Town of Black Mountain Staff Report
Board of Adjustment

Case No: S-25-02 **Hearing Date:** September 18, 2025
Case Name: 399 Blue Ridge Rd **Procedure:** Special Use Permit Evidentiary Hearing

Request:
The applicant is seeking a Special Use Permit to develop the parcel as a Planned Unit Development consisting of what the applicant describes on their application as "50 deeply affordable dwellings." The development is to be a mixture of single-family homes and duplexes.

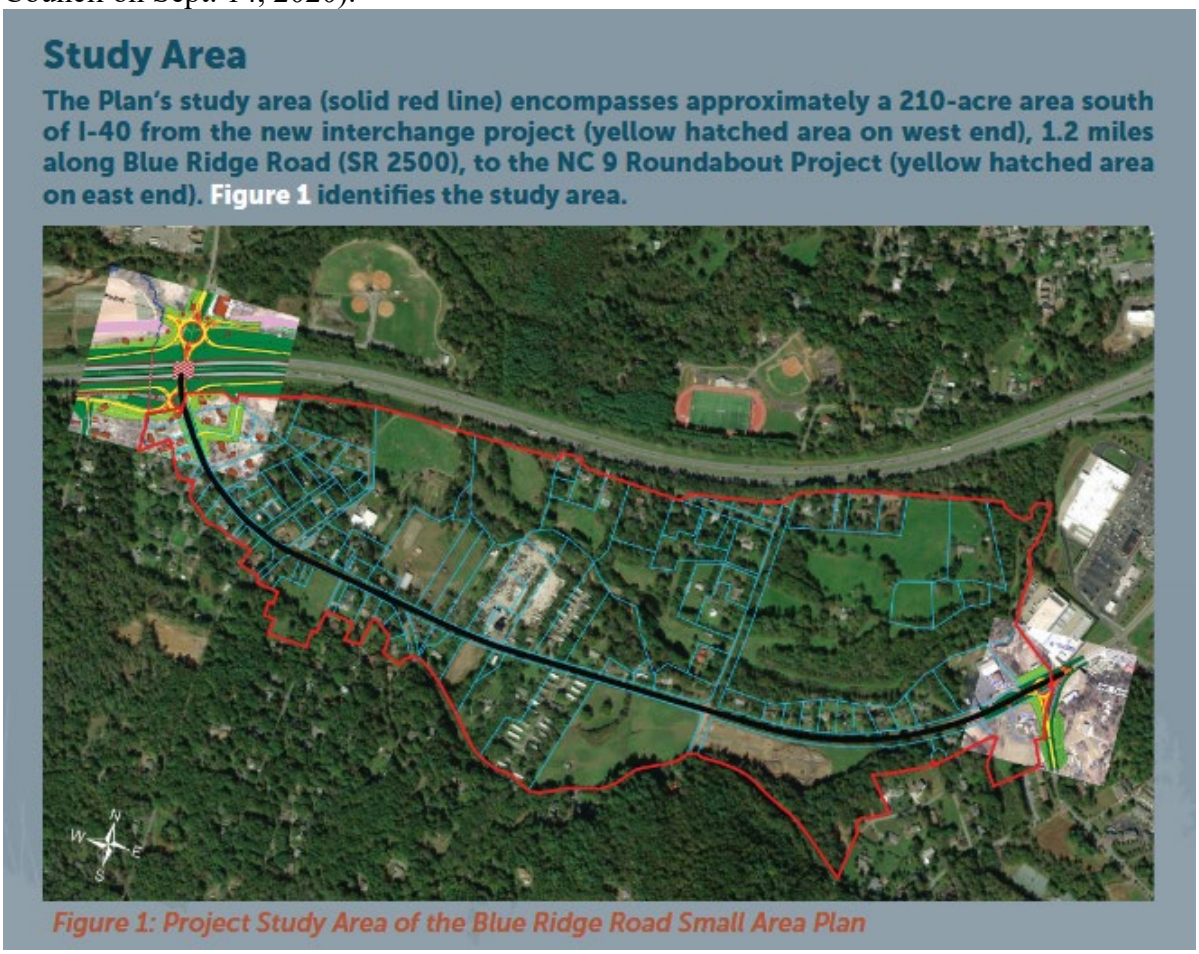
For this checklist item, the applicant wrote: "N/A – Proposed internal greenway connections are shown in place of sidewalks." The site plan does depict – in green – **internal path connections**.

Given that the Blue Ridge Road Small Area Plan calls for a sidewalk and multiuse path along Blue Ridge Road, the Board of Adjustment should seek a **"sidewalk or greenway easement"** along the portion of the parcel that abuts Blue Ridge Road.

The site plan and landscape compliance plan do depict the required "internal pedestrian consideration" (The site plan includes the same green-shaded path that was labeled *Pedestrian Trail* in the previously-submitted version. The revised version is missing the label; the label *Pedestrian Trail* should be added.)

The Board should seek the provision to the Town of **"a minimum eight-foot sidewalk right-of-way"** along the "abutting town dedicated street" of Old Lakey Gap Road.
